Workgroup Consultation Response Proforma**GC0151: Fault Ride through process**

Respondent details	Please enter your details
Respondent name:	Alastair Frew
Company name:	Drax
Email address:	alastair.frew@drax.com
Phone number:	07730697290

Figure 1 – Rough interpretation of Current Compliance Process

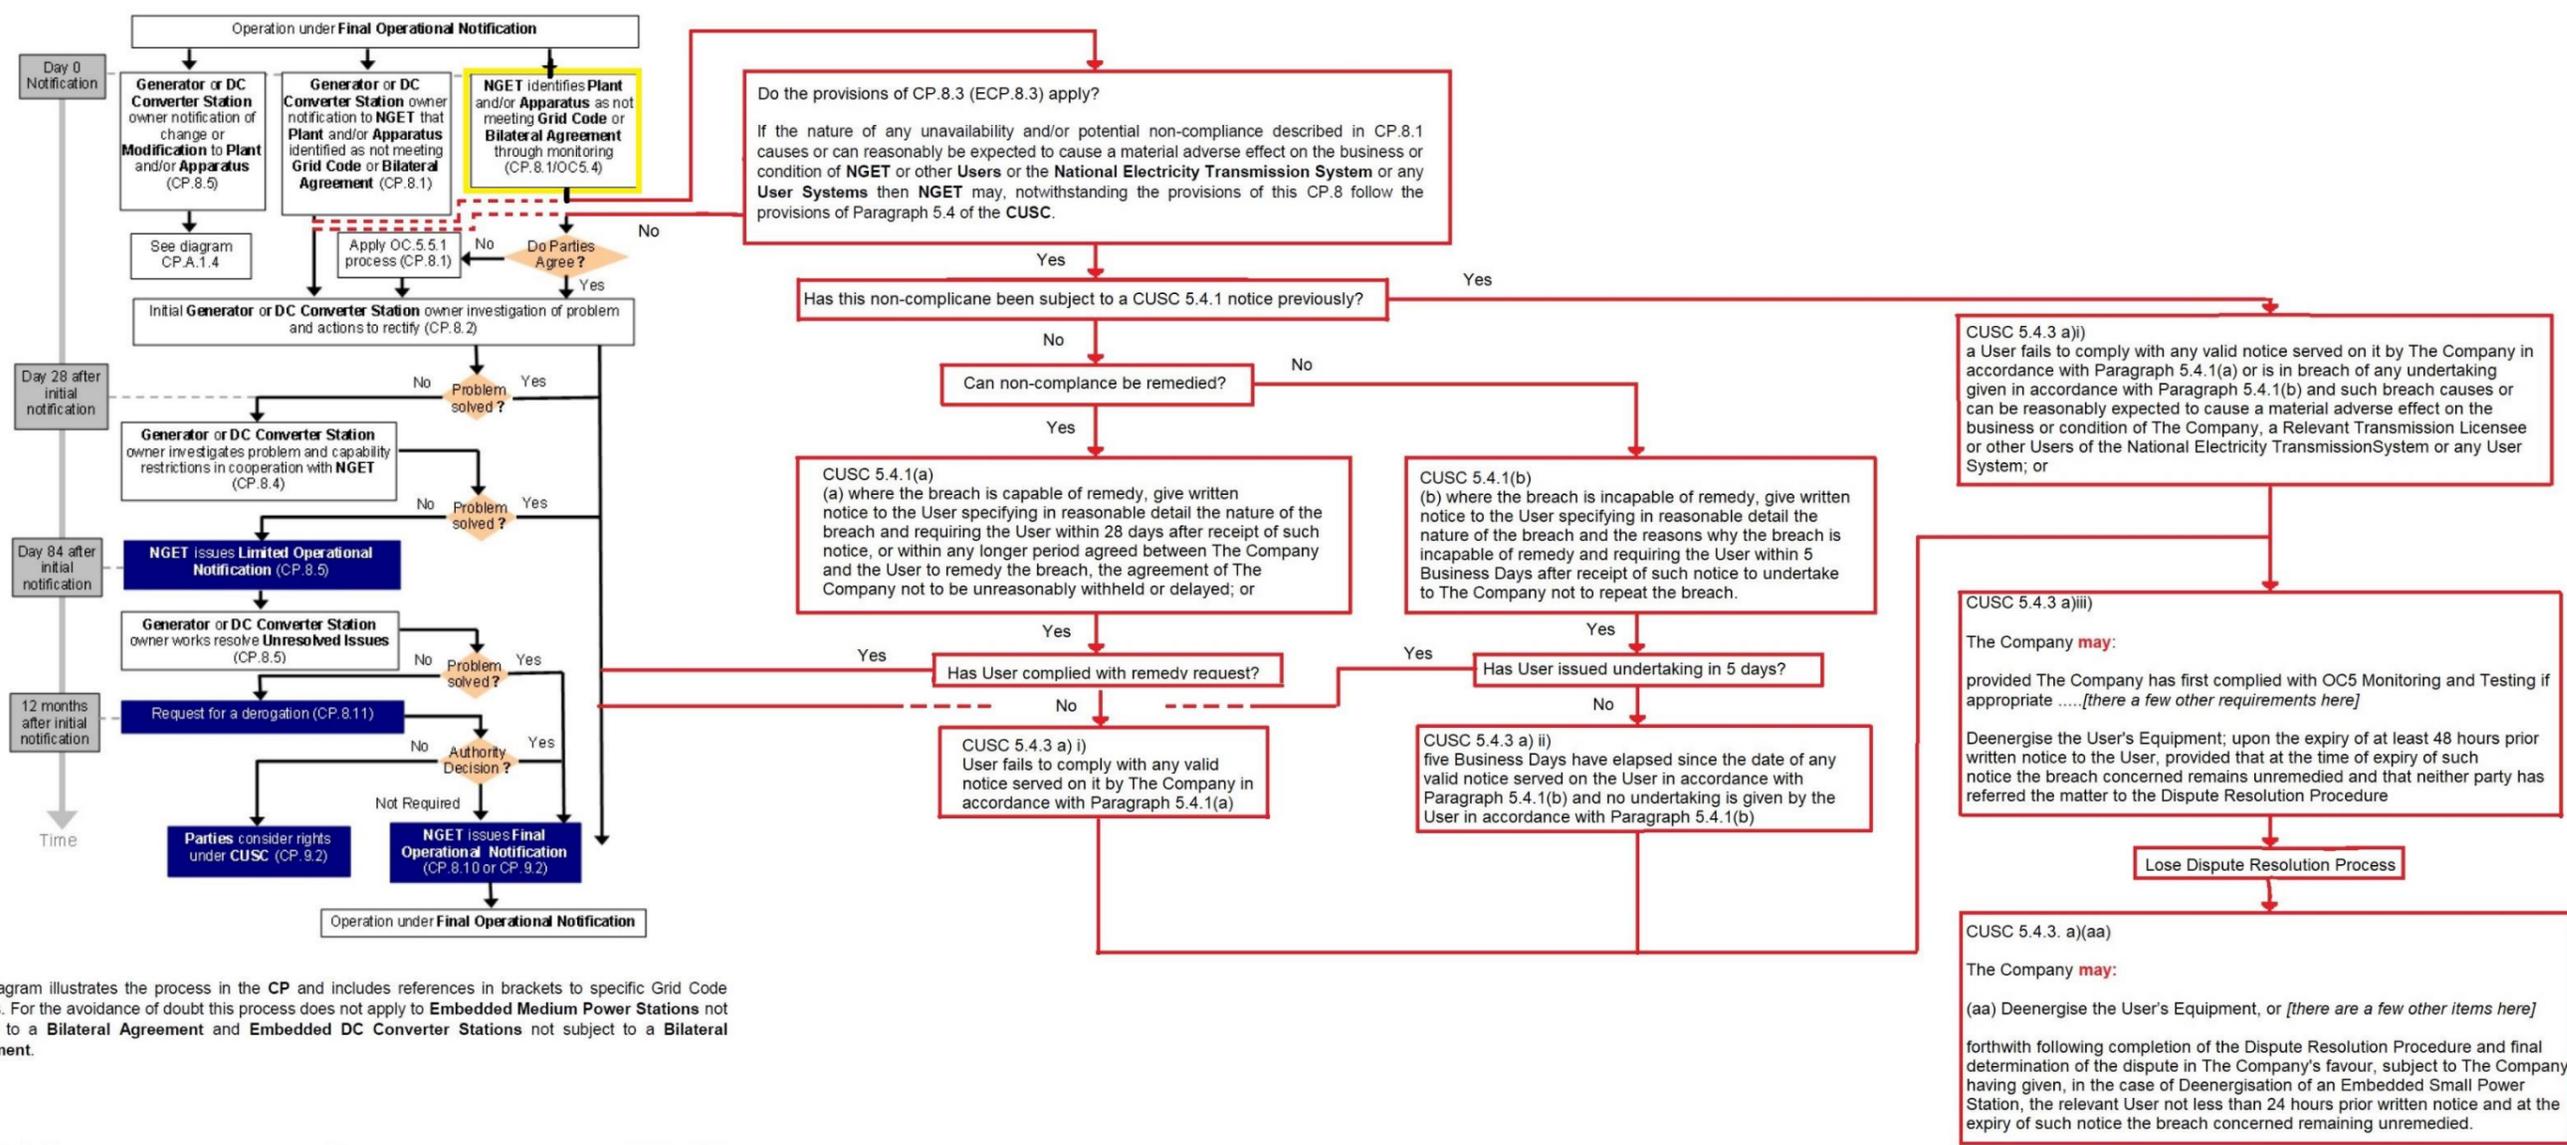
Rough interpretation of how CP.8.3, ECP.8.3 and CUSC 5.4 fit into the Compliance Process
